Service Bulletin

Title: SBEC135-25-02; EC135 Air Conditioner Condenser Wiring Harness

Blower Motor Connector

Summary: The purpose of this Service Bulletin is to provide instructions for replacing

Figure 1: Condenser Assembly EC135-7000-2

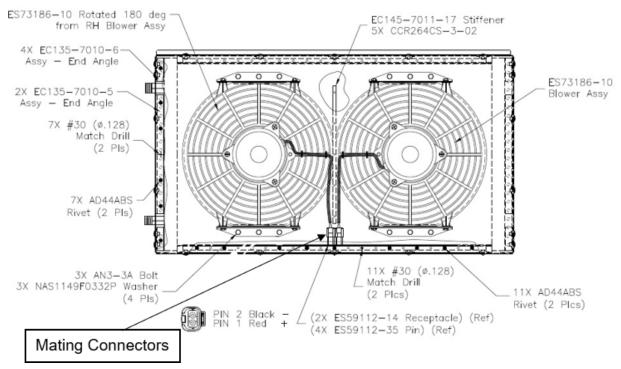
The Molex motor connectors used in the Air Comm Corporation Condenser Assembly EC135-7000-1 and ES73186-9 are now obsolete and have been replaced with Deutsch connectors as built per EC135-7000-2 (shown in Figure 1) and ES73186-10 (Shown in Figure 2).

When replacing the top-level assembly P/N EC135-7000-1 with new P/N EC135-7000-2, it is necessary to replace both of the aircraft side connectors with new P/N ES59112-13. No further changes are then required.

- 8. Locate P/N marking on the condenser assembly and add with indelible ink "SBEC135-25-02".
- After installing or converting both blower assemblies to P/N ES73186-10, locate the
 existing Molex connectors on the aircraft-side leading to the panel relay. The new aircraftside connectors will plug into the mating connectors of the Condenser Assembly EC1357000-2 shown in Figure 1.

Figure 2: Blower Assembly ES73186-10

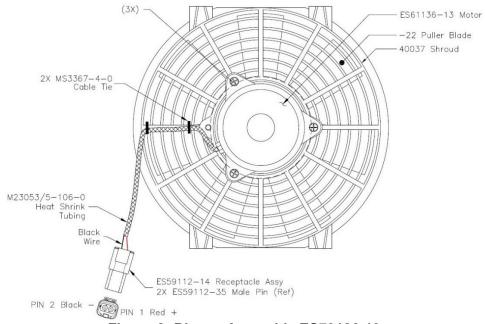
When replacing only one of the sub-component blowers P/N ES73186-9 with new P/N ES73186-10 in the condenser, it is necessary to update the second blower with connector P/N ES59112-14, as well as the two aircraft side connectors with new P/N ES59112-13. This is required to ensure full assembly configuration control and the assembly must be part-marked accordingly.

Figure 3: Electrical Schematic

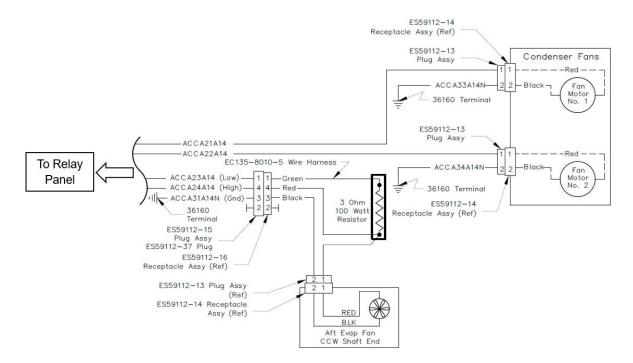
- 5. Insert the red wire into Pin 1, and the black wire into Pin 2 of the Deutsch connector ES59112-14 as shown in the electrical schematic of Figure 3.

- 10. Trim wires of Molex connectors being replaced (Refer to the electrical schematic in Figure 3 for motor labeling):
 - a) For Blower Assembly No. 1, trim wires ACCA21A14 and ACCA33A14N at the existing connector to maintain wire length.

- a) For Blower Assembly No. 1, insert crimped wire ACCA21A14 into Pin 1 and crimped wire ACCA33A14N into Pin 2 of a Deutsch Connector ES59112-13 as shown in Figure 3.

- b) For Blower Assembly No. 2, insert crimped wire ACCA22A14 into Pin 1 and crimped wire ACCA34A14N into Pin 2 of a Deutsch Connector ES59112-13 as shown in Figure 3.

- 14. Ensure contacts are locked in per Figure 4 and engage the wedge lock.
- 15. Reconnect the Condenser Assembly as shown in Figure 3.

Figure 4: Contact Insertion

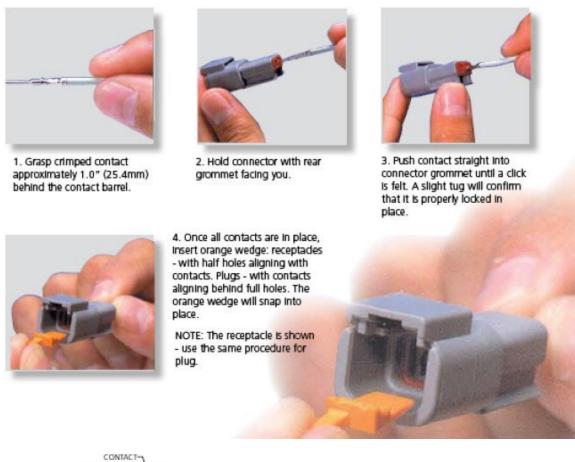
- 6. Ensure contacts are locked in per Figure 4 and engage the wedge lock.
- 7. Locate the P/N marking on any converted blower assembly and add with indelible ink "SBEC135-25-02".

- 12. Crimp a socket contact ES59112-34 to each of the striped wires using Deutsch tool HDT-48-00 crimping tool.
- 13. Insert crimped wires as follows (Refer to Figure 4 for contact insertion instructions):
